22 LANCASTER GROVE

Date: 17th December 2013
Our Ref: 2013/7870/PRE
Your Ref: 9032423
Contact: Charles Rose
Direct Line: 020 7974 1971
Email: Charlie.Rose@camden.gov.uk

**PRE-APPLICATION PLANNING ENQUIRY
22 LANCASTER GROVE LONDON NW3 4PB**

APPEAL BY MISS KATHERINE SOMERS AGAINST THE REFUSAL OF A PLANNING APPLICATION FOR THE ERECTION OF A TWO STOREY BUILDING PLUS BASEMENT FOLLOWING THE DEMOLITION OF EXISTING BUILDING TO PROVIDE FOUR DWELLINGHOUSES (4 X 5-BED)

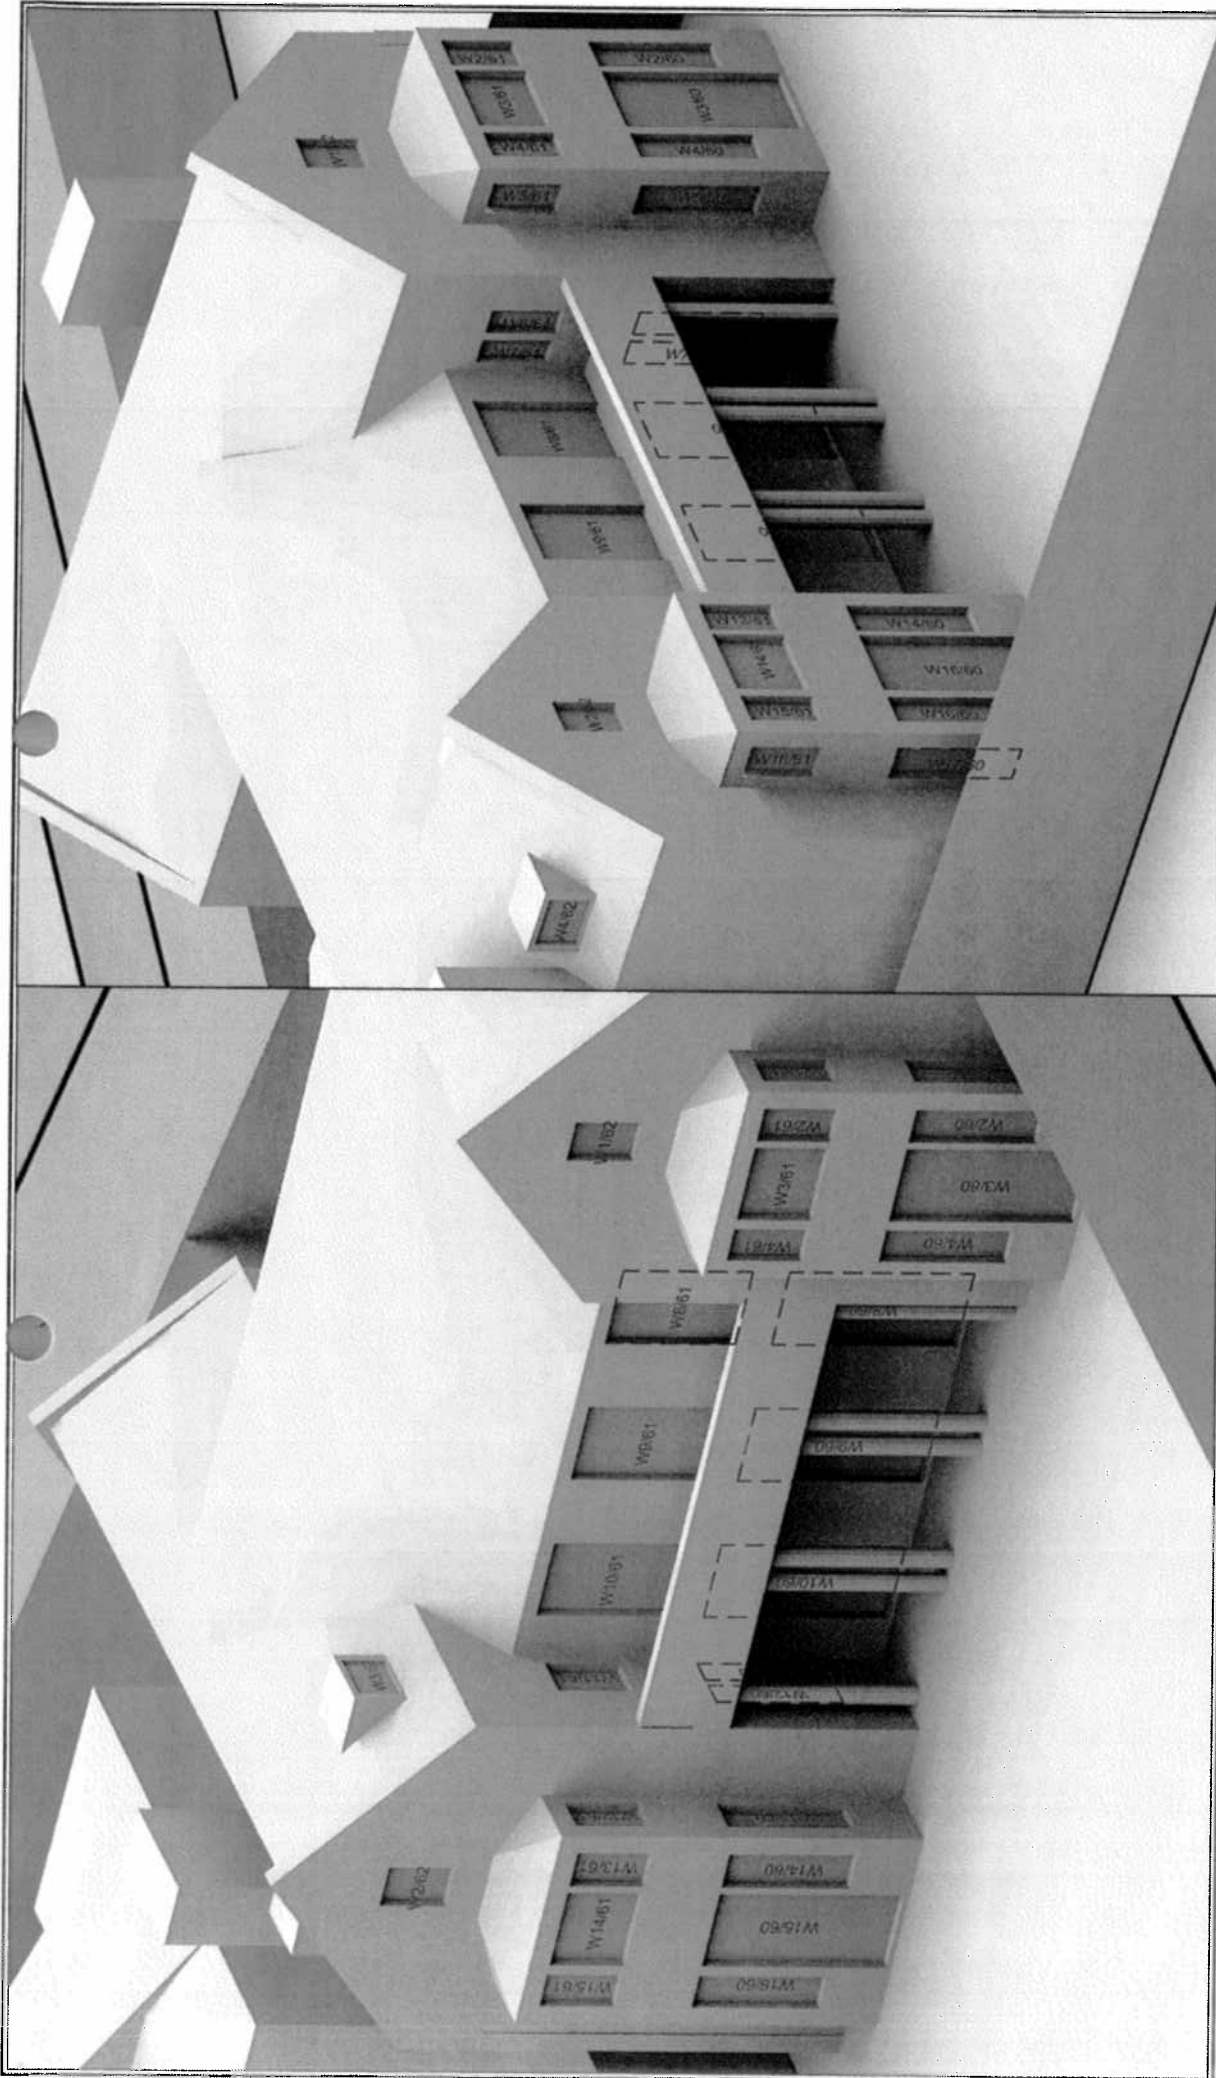
- 4.2 Located to the West of the development site this property is currently under construction in accordance with a Planning Consent. It has been possible to 3d computer model and analyse this property based upon the Consented Planning drawings. Our understanding of which is illustrated in drawing P382/WL/02 in Appendix B.

- 4.4 There are 3 windows (8%) out of 37 within the building which do not satisfy the BRE VSC window face daylight test in that they are altered by more than 20%. These are highlighted in drawing P382/WL/02 in Appendix B.
